Office Action Summary	Application No. 10/813,904	Applicant(s) KALFAS ET AL.	
	Examiner ANDREW YANG	Art Unit 3775

DETAILED ACTION

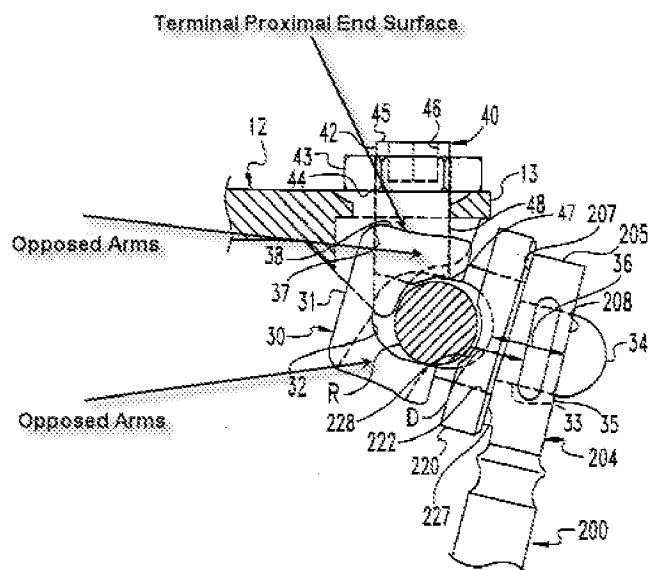
Montague et al. discloses a spinal fixation system having two bone anchors 200 having bone engaging portions and rod receiving portions 30. Each rod receiving portion can be considered to have opposed arms having a proximal terminal end surface as pictured on the next page. A rod R is disposable between the opposed arms and a connecting plate 10 has a distal surface that bears against the proximal terminal end surface of the opposed arms (Column 7, Lines 50-51). A set screw 40 threadably

engages the rod receiving portion via hole 37 and fixes the rod to the bone anchor 200.

A cap 43 is threadably engaged with the set screw 40, via a bore in the cap 30, such that the cap 43 fixes the plate 10 to the rod receiving portion 30. The connecting plate 10 defines an opening 18 at an end and a spanning portion 11 extending therefrom. The set screw extends through the opening 18. The connecting plate includes a buttress 14 at a distal side of the spanning portion 11. A set of anchors are connected by a rod, and a set of anchors are connected by the connecting plate 10.

The connecting plate has a distal bearing surface 16 that is domed and can be considered partially spherical. As seen in figure 10, the cap has a distal bearing surface that is domed that mates with a proximal bearing surface of the connecting plate.
